**ADDENDUM NO. 5**

FINANCIAL ITEM NUMBER: 415474-2-52-01, 415474-2-52-02, and 415474-2-56-01  
CONTRACT NUMBER: E3U76  
DESCRIPTION: Design Build for SR 30 (US 98) Brooks Bridge No. 570034

Attached for your use is a redline revision to the RFP document previously distributed. The following is a summary of the revisions:

Figure 3: Lighting Design and Construction – West of Bridges

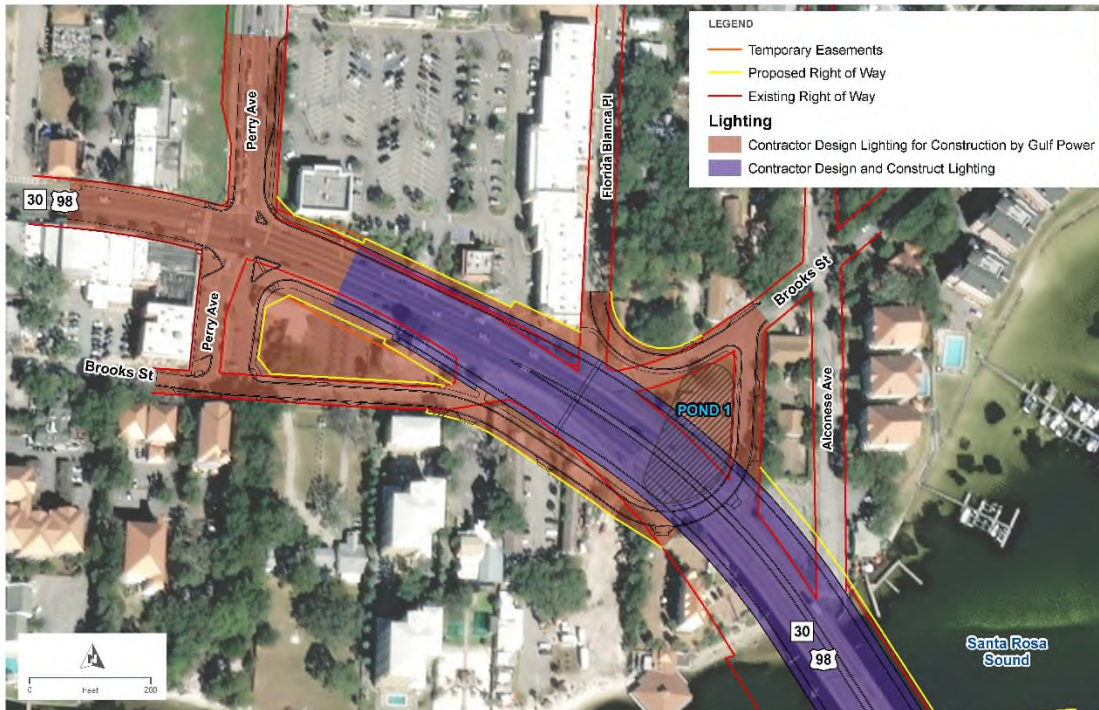
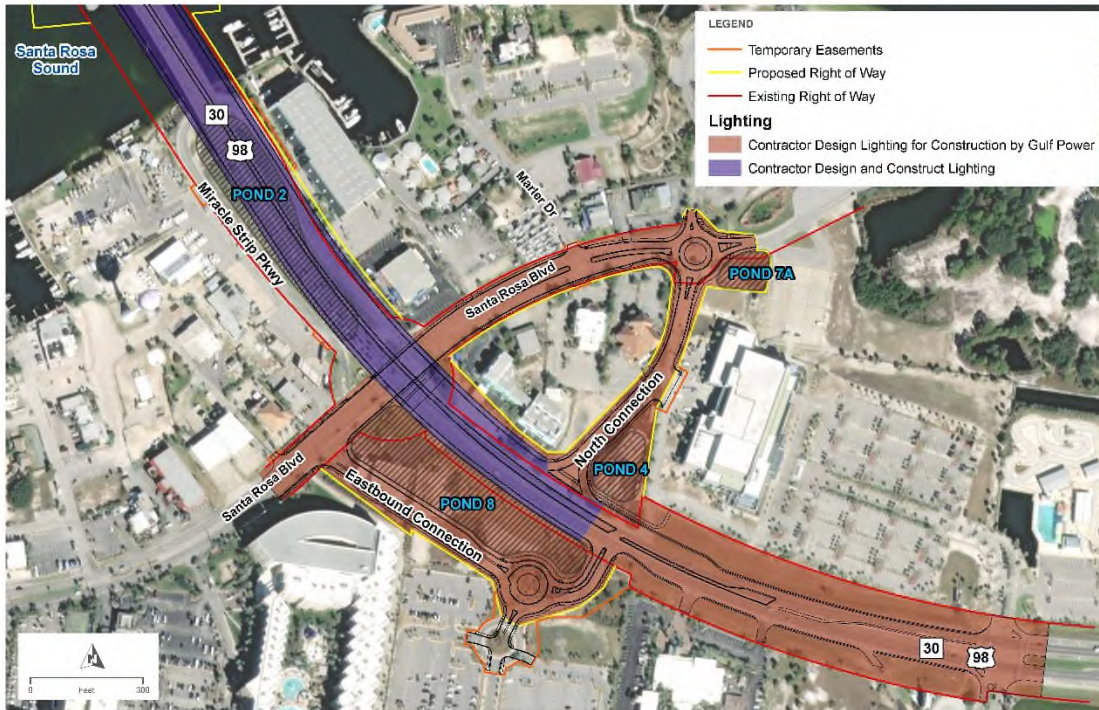
- Corrected intent of Design-Build Firm's responsibly for lighting to be installed by Gulf Power

- Modified location requirement of roadway lighting

The Design-Build Firm shall design all remaining lighting which will be constructed by Gulf Power. See Figures 3 and 4 below depicting the approximate limits of lighting design and construction west and east of the proposed bridges. There is existing lighting on SR 30, Brooks Street, Florida Blanca Place, and Santa

The proposed lighting is to be **typical** FDOT Conventional Lighting of the Light Emitting Diode (LED) type with full cutoff distribution to reduce sky glow as much as possible. High mast lighting is not allowed on this project.

The existing lighting in conflict with the proposed design shall be removed. **Temporary lighting shall be provided if existing lighting is removed prior to installation of proposed lighting.** The Design-Build Firm shall remove lighting in conflict and stockpile on site for the Department's contamination contractor to remove from the project. Contact the District Contamination Coordinator at (850) 330-1511.
